## **BEDSOLE SUBDIVISION, RESUBDIVISION OF LOT 1**

APPLICATION NUMBER 11 DATE August 4, 2016

REQUEST Subdivision

# DETAIL SITE PLAN

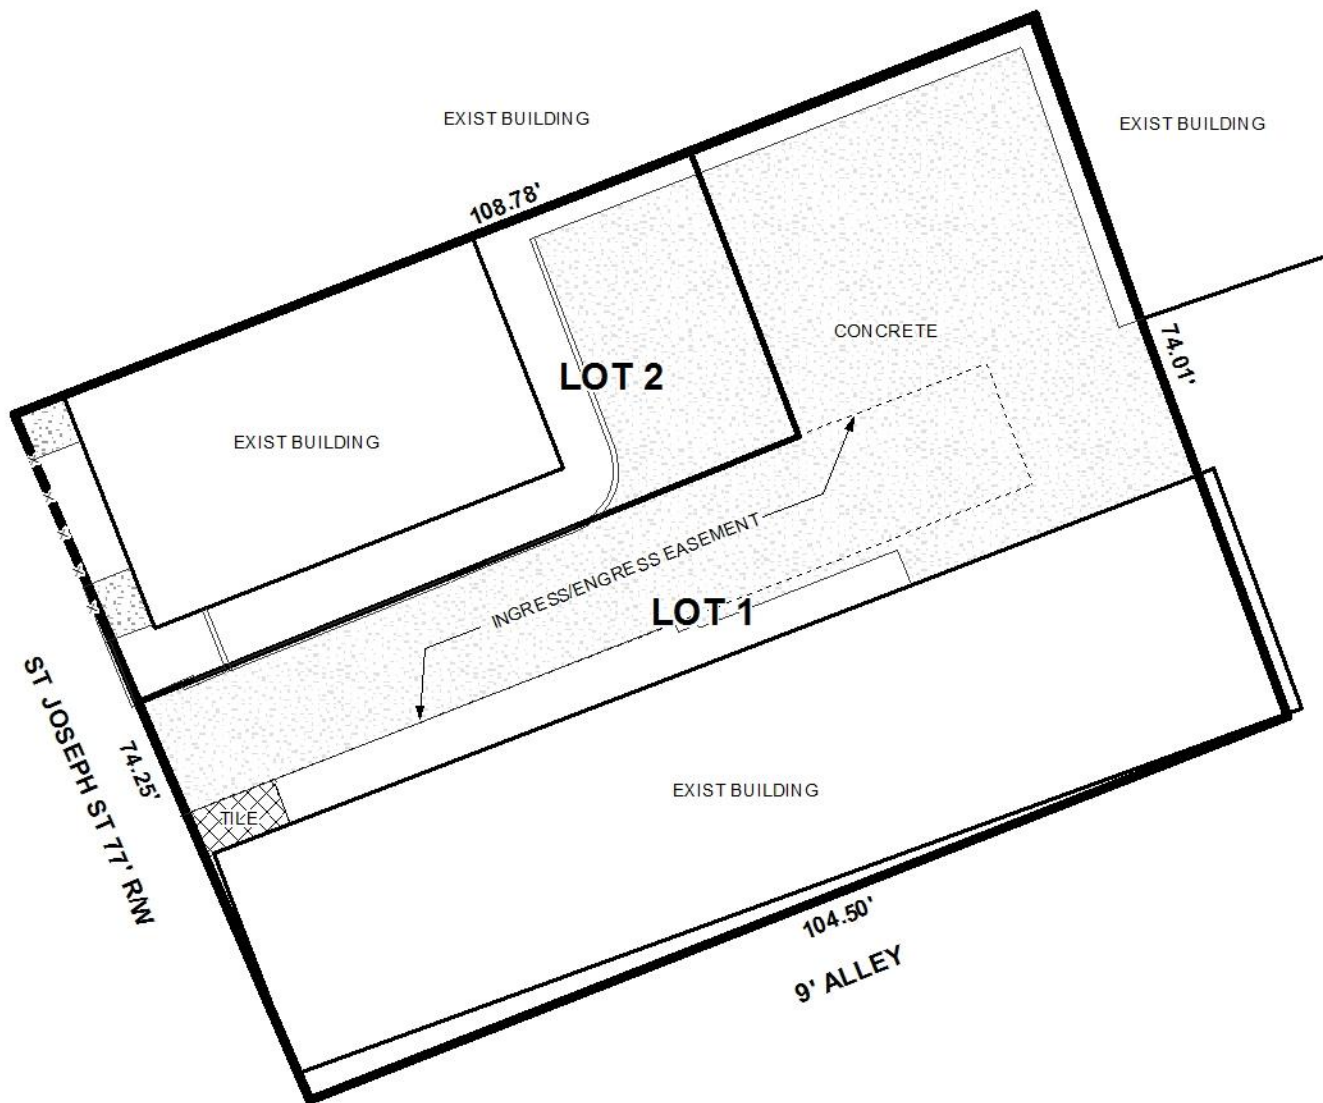
The proposed lots are developed and are located in the Lower Dauphin Street Historic District, as well as in a T-6 Sub-District of the Downtown Development District. The lots have frontage along Saint Joseph Street, an "A" street with curb and gutter requiring a 50' right-of-way. The plat illustrates a 77' right-of-way along Saint Joseph Street and, as such, no additional dedication should be required.

Both proposed lots share a curb cut, the result of an Ingress/Egress Easement, to which each lot should be limited with any changes in its size, design, and location to be approved by Traffic Engineering and conform to AASHTO standards.

The proposed lot, as depicted, meets the minimum width requirements (14 feet) for a T-6 Sub-District of the Downtown Development District, with lot sizes provided in both square feet and acres. This information should be retained on the Final Plat, or a table providing the same information should be furnished on the Final Plat, if approved.

The maximum building setback line of 10 feet along Saint Joseph Street, required by the Downtown Development District, is not shown on the preliminary plat and should be illustrated on the Final Plat, if approved. It should be noted that such a setback line varies from the Subdivision Regulations and would require a waiver of Section V.D.9.

- 1) a note on the Final Plat stating the lots are limited to their existing shared curb cut to Saint Joseph Street, with any changes in its size, design, and location to be approved by Traffic Engineering and conform to AASHTO standards;
- 2) retention of the lot sizes in square feet and acres on the Final Plat, or the furnishing of a table on the Final Plat providing the same information, adjusted for dedication;
- 3) revision of the Final Plat to illustrate the 10-foot maximum building setback line along Saint Joseph Street;
- 4) compliance with Engineering comments: (*FINAL PLAT COMMENTS (should be addressed prior to submitting the FINAL PLAT for acceptance and signature by the City Engineer): A) Provide all of the required information on the SUBDIVISION PLAT (i.e. signature blocks, signatures, certification statements, written legal description, required notes, legend, scale,*
